**National Emission Standards for
Hazardous Air Pollutants for Source
Categories: Organic Hazardous Air
Pollutants From the Synthetic Organic
Chemical Manufacturing Industry and
Other Processes Subject to the Negotiated
Regulation for Equipment Leaks; Final
Rule**

[AD-FRL-6923-8]

ACTION: Final rule; amendments.

Subpart F—National Emission Standards for Organic Hazardous Air Pollutants From the Synthetic Organic Chemical Manufacturing Industry

Figure 1. ALTERNATIVE EXPERIMENTAL METHODS FOR DETERMINING THE FRACTION OF ORGANIC COMPOUND BIODEGRADED (Fbio) IN A BIOLOGICAL TREATMENT UNIT

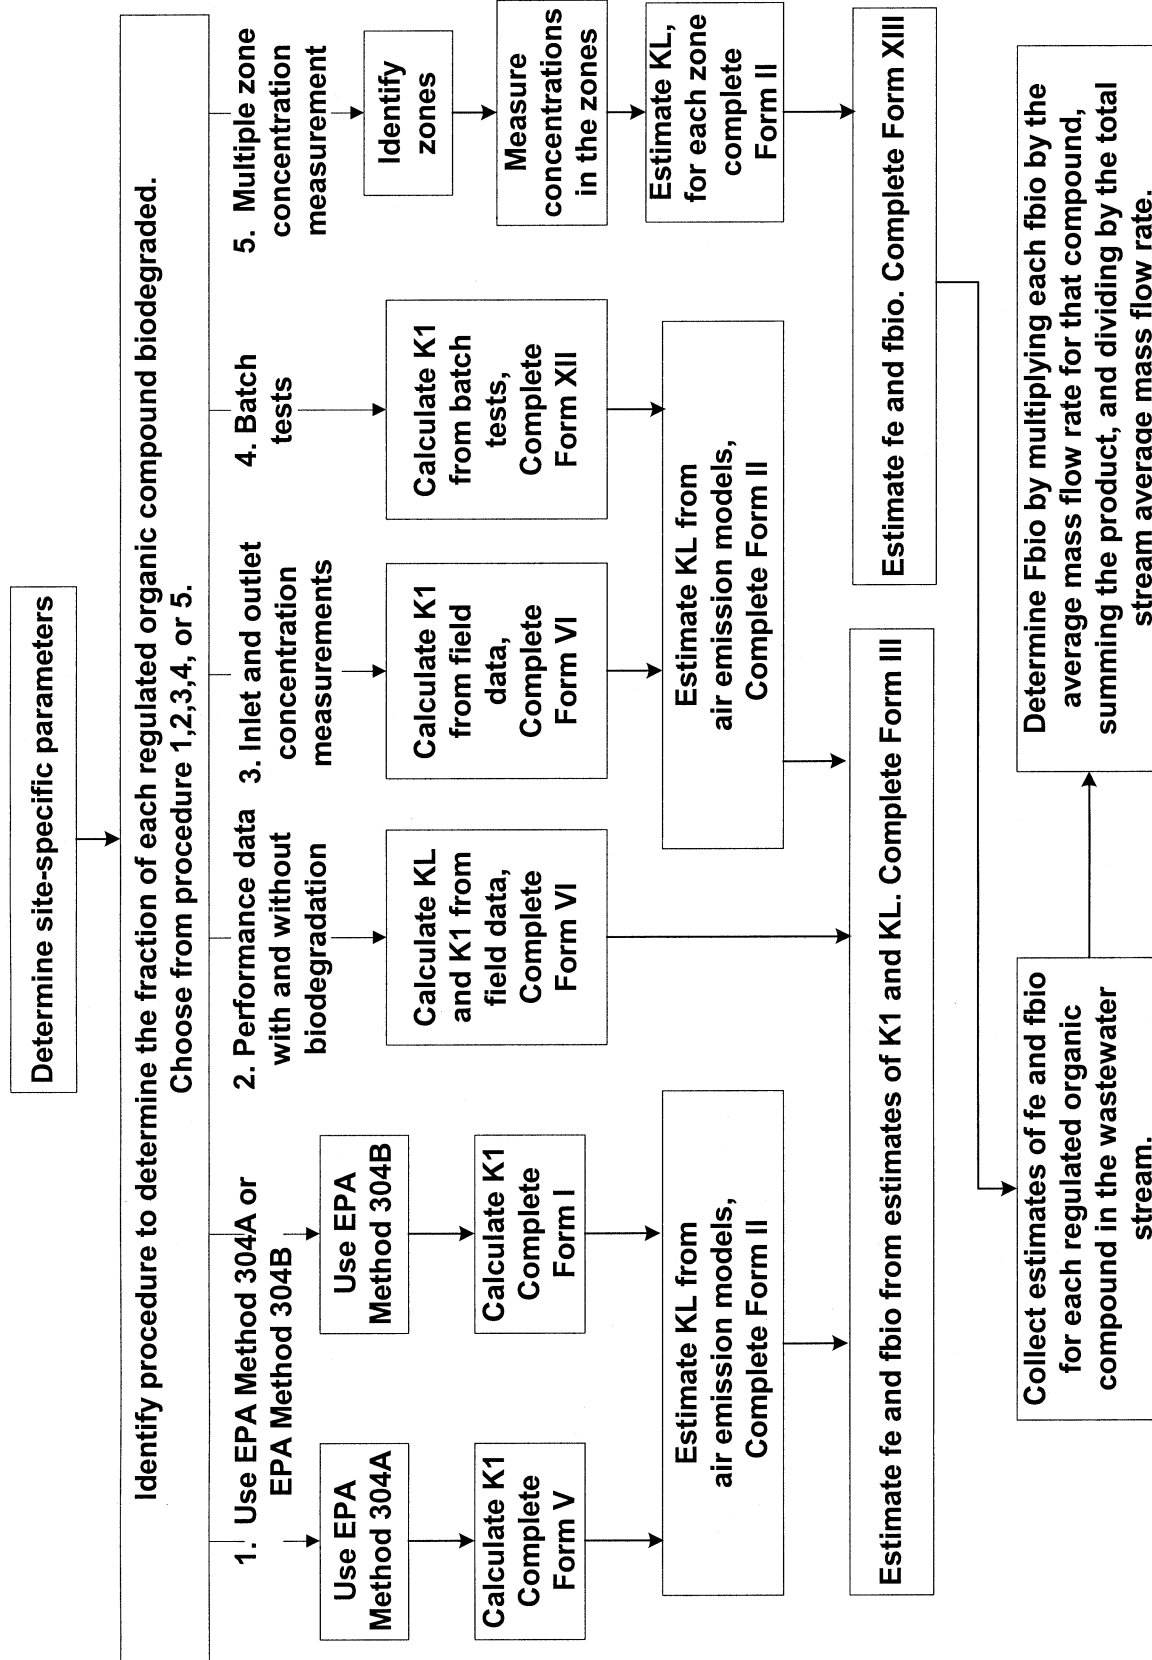
g. Revising Figure 1; and

performance data on a biotreatment unit prior to and after addition of the microbial mass. An example where Procedure 2 could be used is an activated sludge unit where measurements have been taken on inlet and exit concentration of organic compounds in the wastewater prior to seeding with the microbial mass and startup of the unit. The flow chart in figure 1 outlines the steps to use for each of the procedures.
